CHECK LIST FOR PRIVATE SEWAGE DISPOSAL SYSTEM, DATA & DESIGN

Re: 14701 Bodega Highway
Bodega, CA 94922
APN: 026-120-006
Permit #: SEP11-0620

Re: Site evaluation at 14701 Bodega Highway in Occidental, CA 95464
APN: 026-120-006, Permit #: SEV12-0339

**STANDARD LEACHFIELD WASTEWATER
SYSTEM IMPROVEMENTS for
KISTLER VINEYARDS
at POZZI RANCH
14701 Bodega Hwy. Sonoma County, CA
APN: 026-120-006**

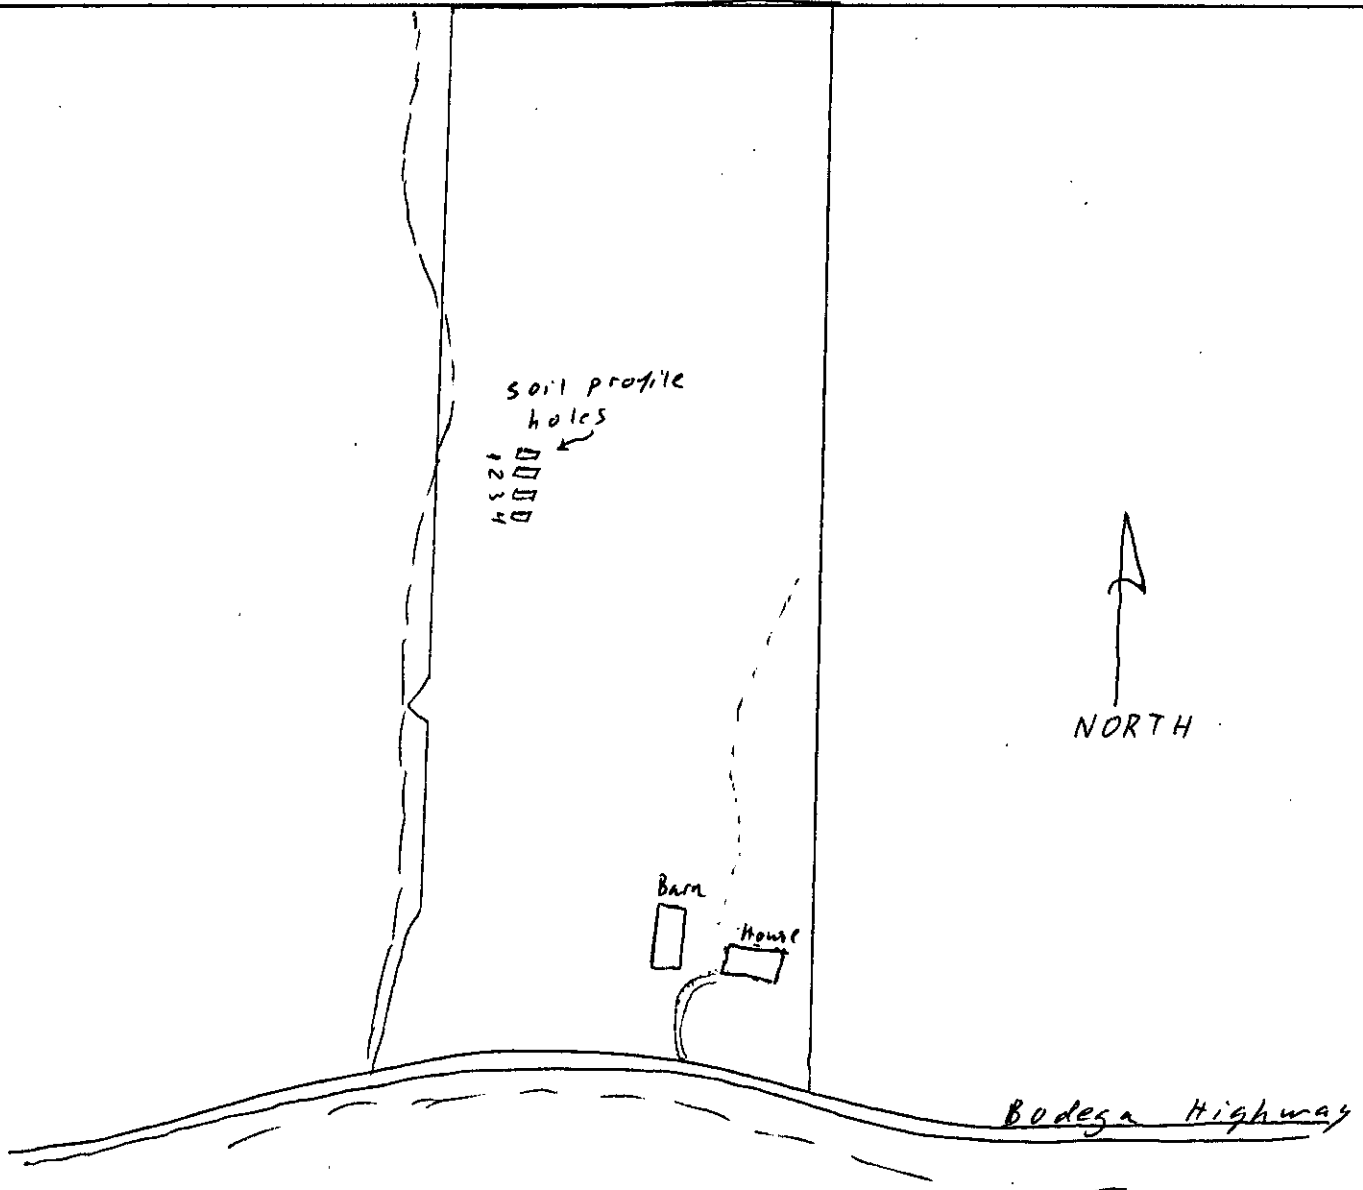
We conducted site and soil evaluations on July 11, 2012 at 2:30 p.m. to find a second suitable area to relocate the primary leach field. We observed and logged four soil profile holes, labeled as holes 1 to 4. You can find the soil log and site map at the attached page. The site is within zone 3 or 4 in the water availability map and identified as Goldridge fine sandy loam or Steinbeck loam soil in the Sonoma County soil survey map.

The area has a potential for a 36-inch standard system which would include 18 inches of rocks below the leach pipe. Please perform a regular percolation test at 36 inches and 72 inches to determine the soil permeability.

C2
 SHEET NO. 2
 DATE: August 7, 2011
 DRAWN BY: CHD
 CHECKED BY: CHD
 PROJECT: POZZI RANCH WINERY

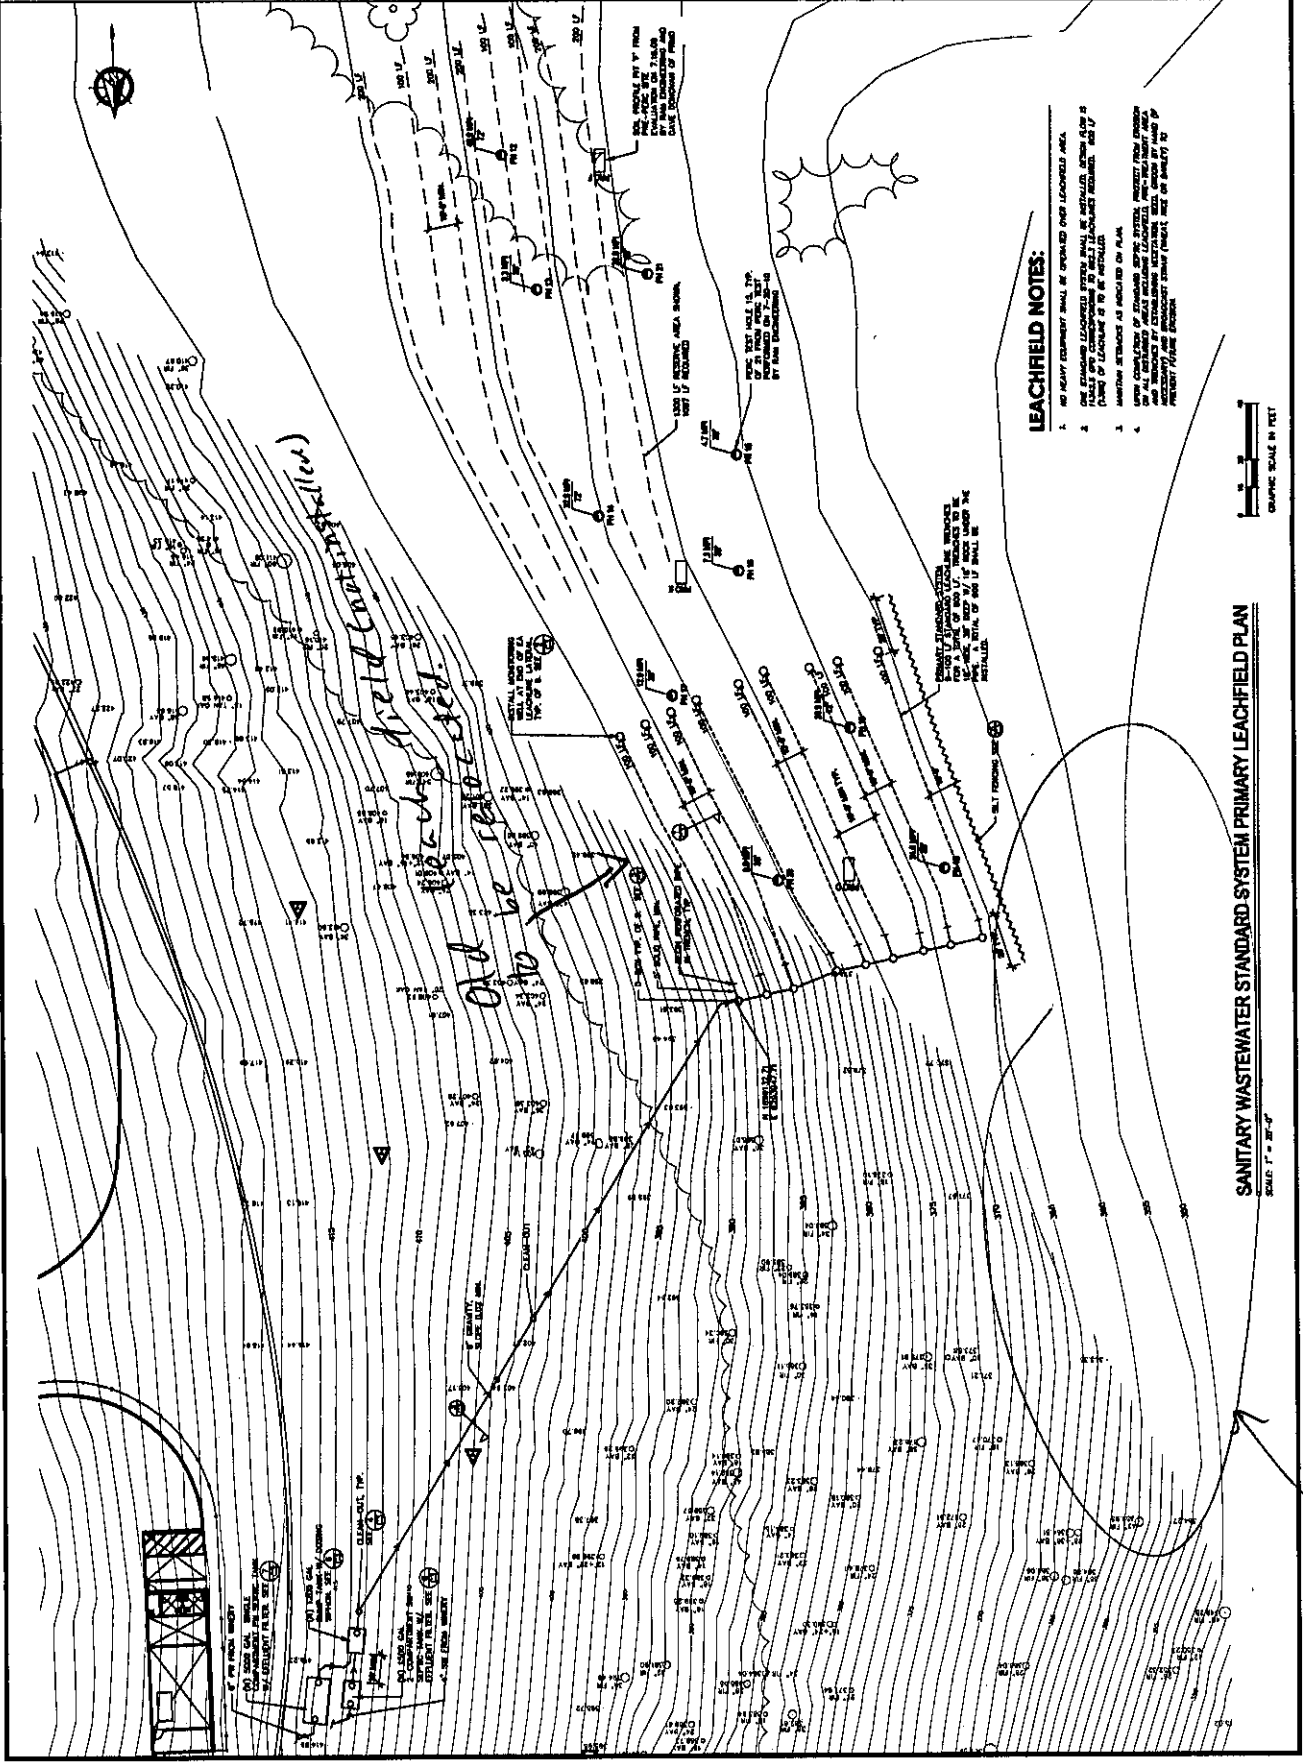
- ① Please check and make sure the north arrow is pointing at the appropriate direction on sheet C2 of the septic plan.
- OK. 2. Please show an erosion control for the primary leach field on the plan.
TN.
- OK. 3. The plan will need to include all the soil profile holes with labels.
TN.
- OK. 4. Please use serial distribution box for each leach line with gravity flow to the leach
TN. line; or provide equal distribution to the leach lines with a pump; or divide the domestic flow from the process flow in a separate leach field.
- OK. 5. The septic system with more than 500 feet of leach line will need to meet the
TN. requirements in Section 9-2-3 (Dosing of leachfield) in the "Regulations for Onsite Sewage Disposal in Sonoma County." Here is the link to the requirement:
<http://www.sonoma-county.org/prmd/docs/policies/9-2-3.pdf>
